Traffic Impact Study

Crossroads-Meadowbrook & Reagan Ranch Colorado Springs, Colorado

PCD File No. CR201 & SP207

CROSSROADS-MEADOWBROOK & REAGAN RANCH
 COLORADO SPRINGS, CO
 2026 RECOMMENDED LANE CONFIGURATIONS

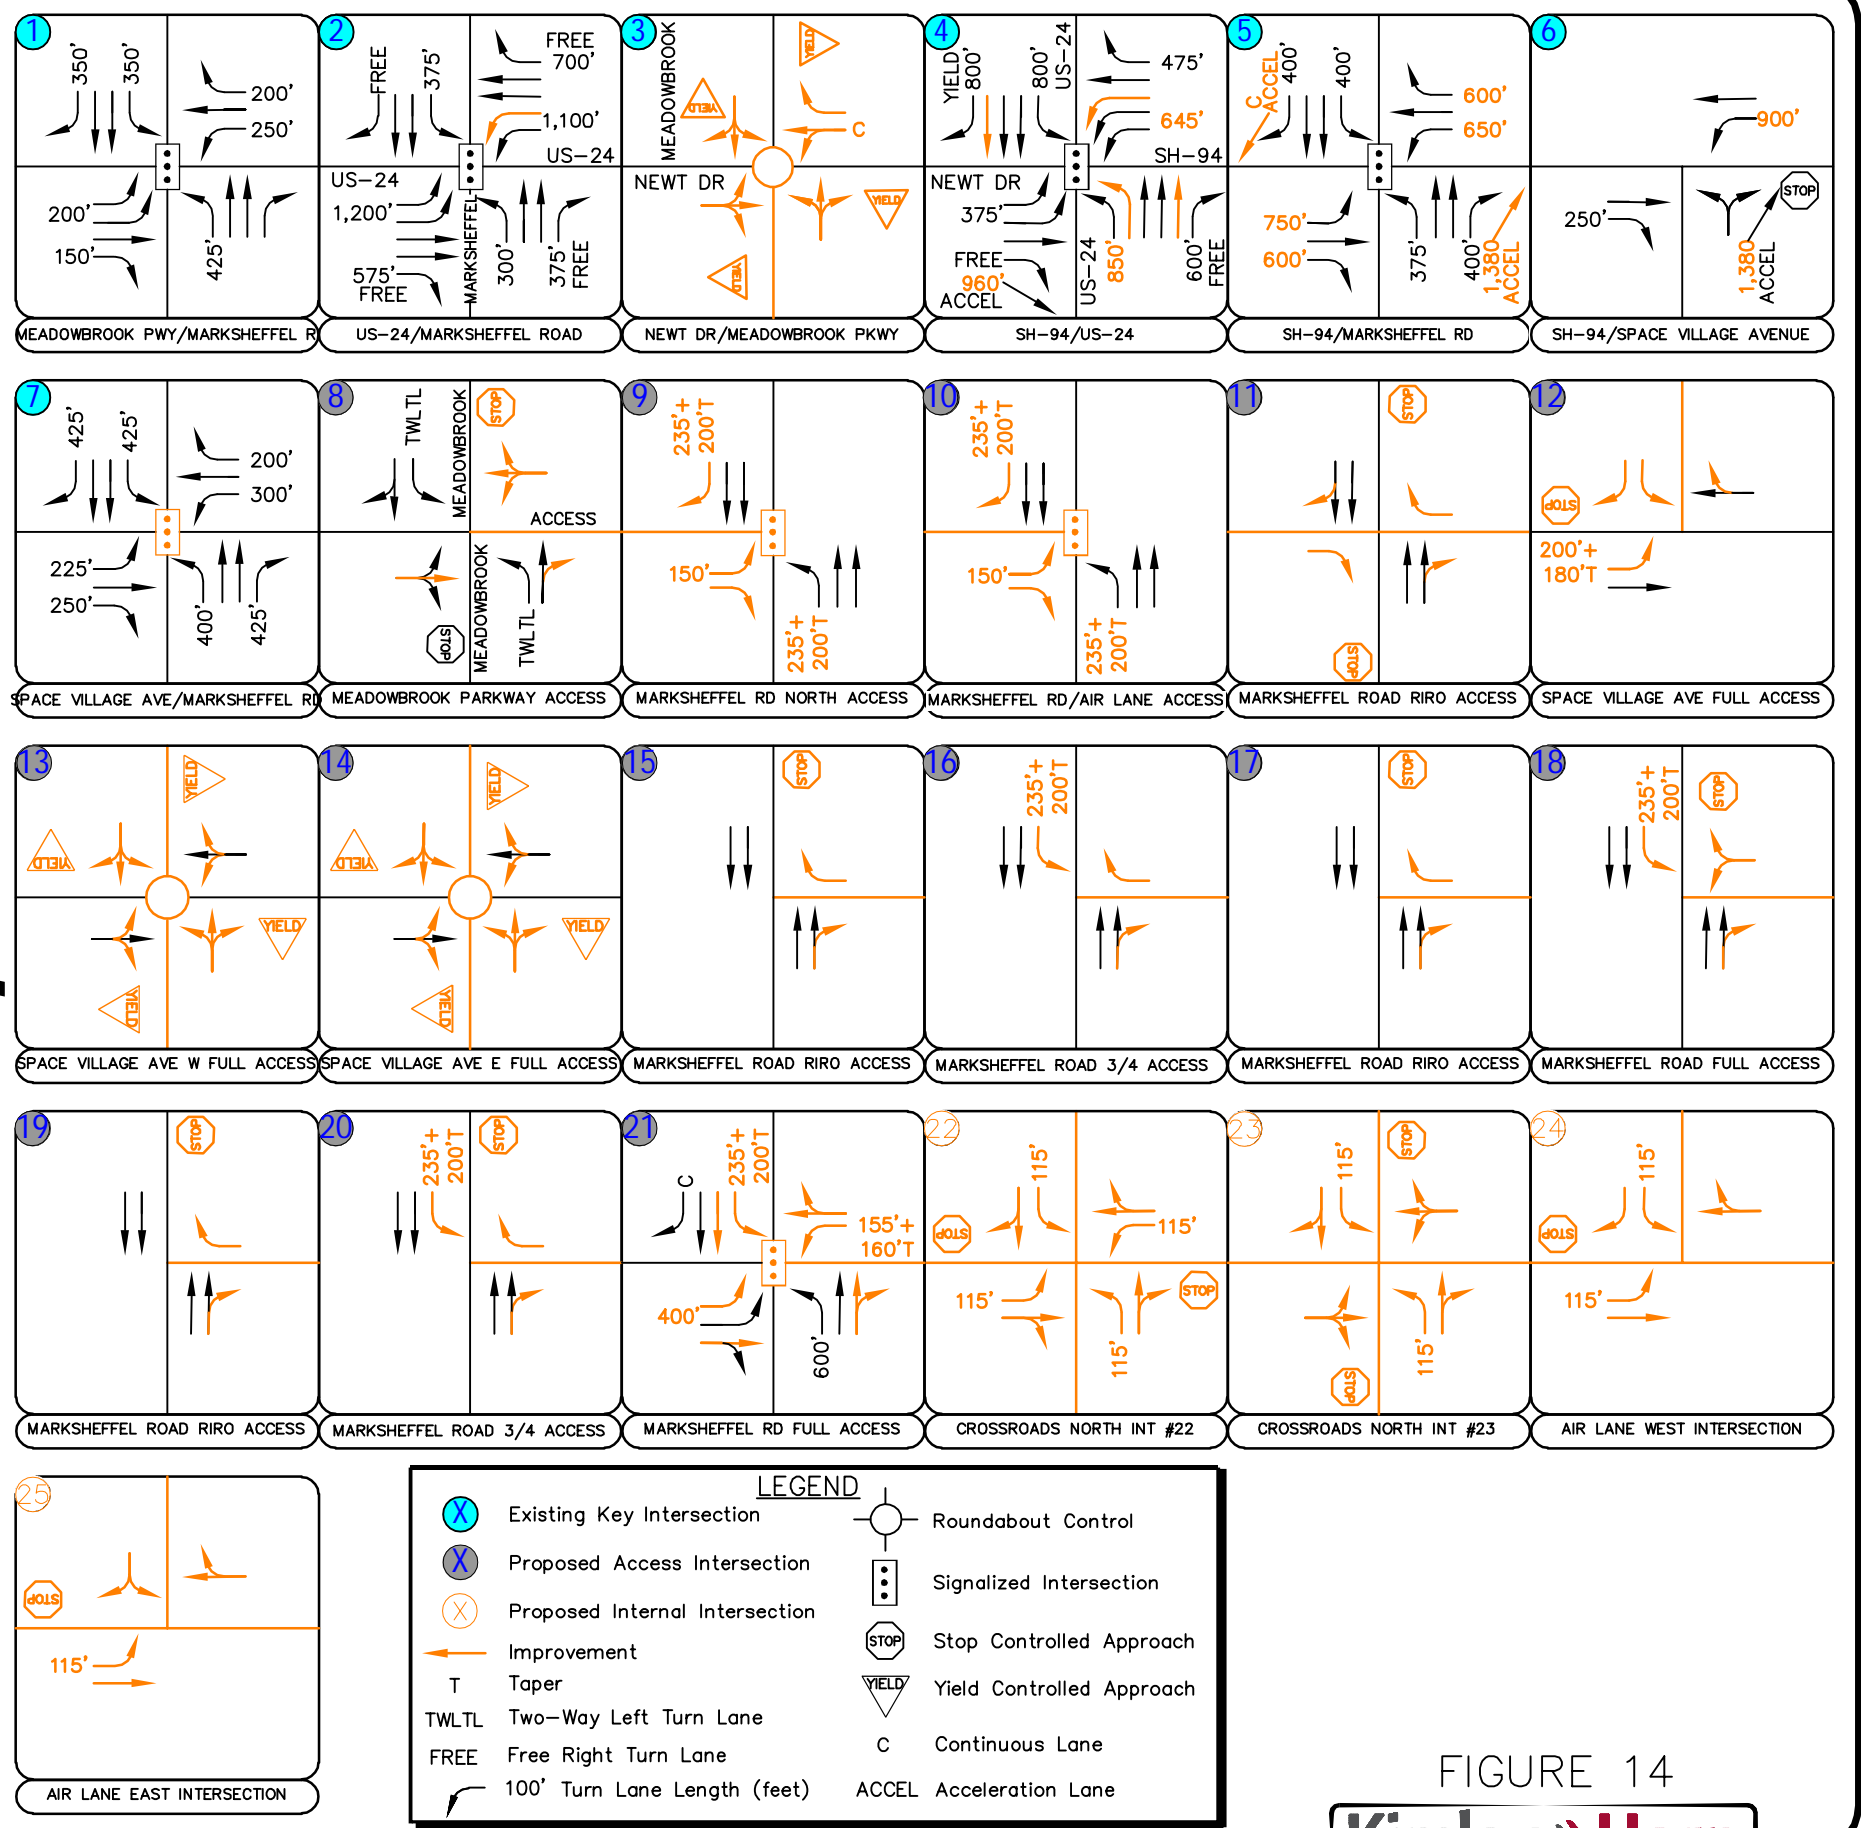
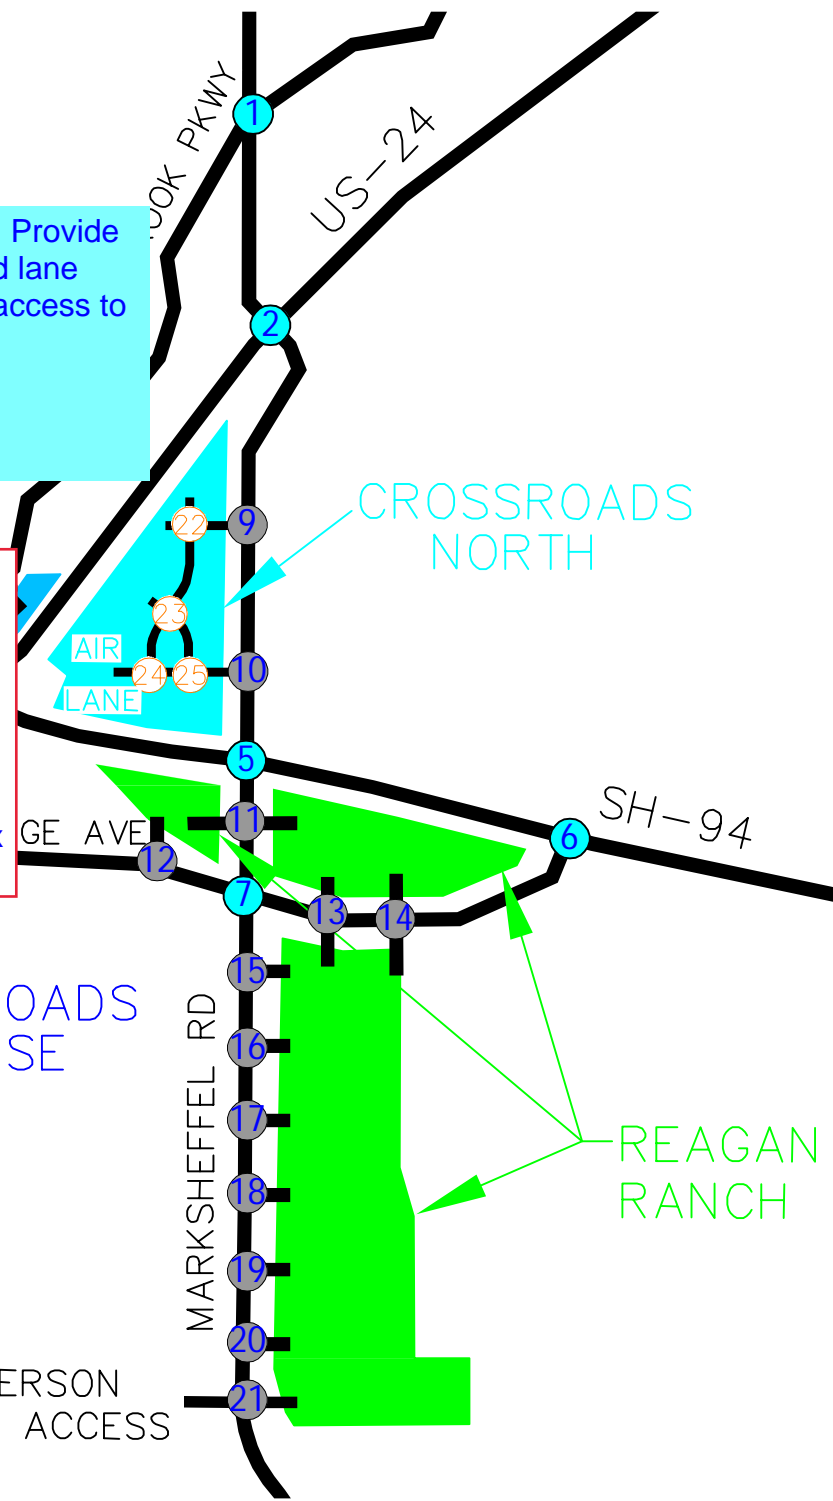
Revise to 13' per ECM

See comment on page 26. Provide analysis and recommended lane configuration for the three access to Meadowbrook Pkwy.

The three accesses along Meadowbrook Parkway have been incorporated in a addendum traffic study letter for Crossroads Mix Use.
